Smart Radio Interface Box User's Guide

Add to SRIB manual (6880309F20-A) for „D“ version

INSTRUCTION MANUAL REVISION

MANUAL
AFFECTED: 68P80309F20-A, Smart Radio Interface Box User's Guide

RLN1015B with leaded diode

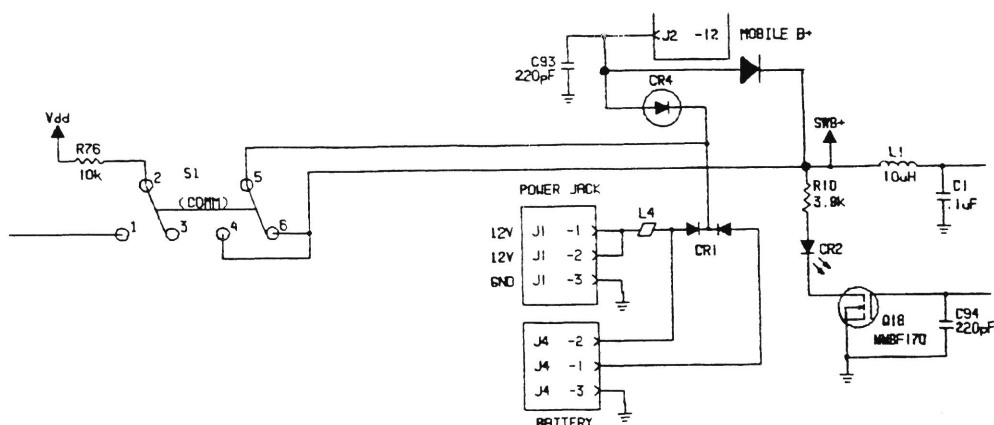
The attached electrical schematic for the RLN1015A is the same for the version B models except in that area where MOBILE B+ (J2-12) enters SWB+. The RLN1015B has a leaded diode (Part Number 4883654H01) soldered between J2-12 and S1-6. The diode's anode is soldered to J2-12, and the diode's cathode is soldered to S1-6. This diode powers the SmartRIB up when the unit is attached to a powered up mobile radio. Note that the position of the diode defeats the operation of S1. This is intentional, to keep the mobile radio from keying up when an unpowered SmartRIB is attached. This modified portion of the schematic appears below.

Later version RLN1015C with printed circuit board change

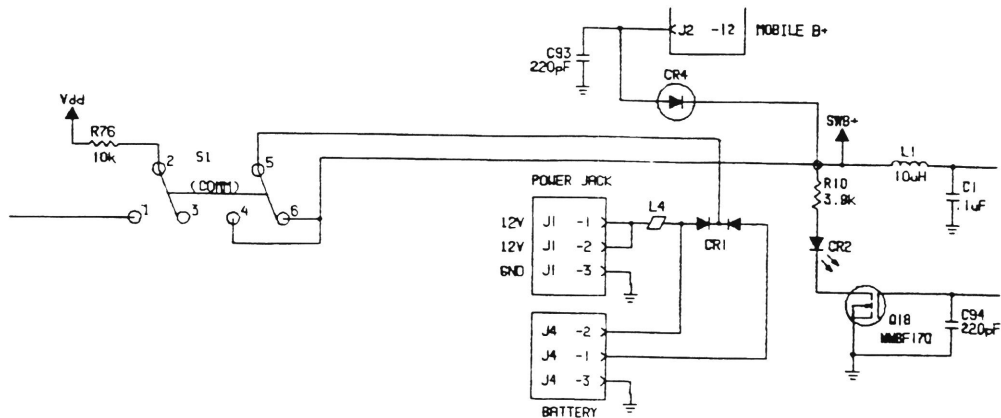
The attached electrical schematic for the RLN1015A is the same for the version C models except in that area where MOBILE B+ (J2-12) enters SWB+ and in the Crystal Pull circuit. Early versions of the RLN1015C have a leaded diode (Part Number 4883654H01) soldered between J2-12 and S1-6. The diode's anode is soldered to J2-12, and the diode's cathode is soldered to S1-6. This diode powers the SmartRIB up when the unit is attached to a powered up mobile radio. Note that the position of the diode defeats the operation of S1. This is intentional, to keep the mobile radio from keying up when an unpowered SmartRIB is attached (see the section titled Power up for complete details). This modified portion of the schematic appears above in the schematic titled Early version RLN1015B with leaded diode. Later versions of the RLN1015C implement the diode change on the printed circuit board. In these versions, the cathode of CR4 is electrically connected to S1-6. This version of the circuit is shown below. Functionally, the later version is identical to the early C version, powering the SmartRIB up when the unit is attached to a powered up mobile radio.

RLN1015C and Later Model Crystal Pull Circuit

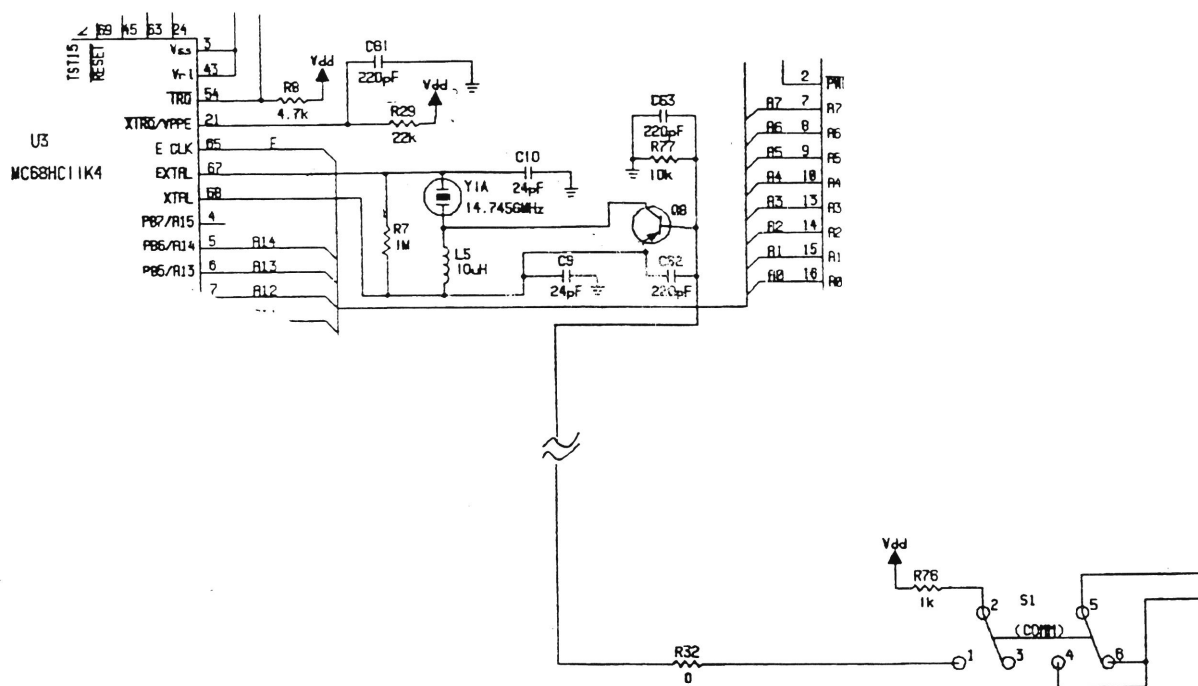
The RLN1015 C model Crytal Pull circuit differs from the A model Crystal Pull circuit in that crystal pull transistor Q8 has been changed from an NPN device to a PNP device, the value of R77 has been changed from 100kohms to 10kohms, and the value of R76 has been changed from 10kohms to 1kohm. These changes are shown in the schematic below.
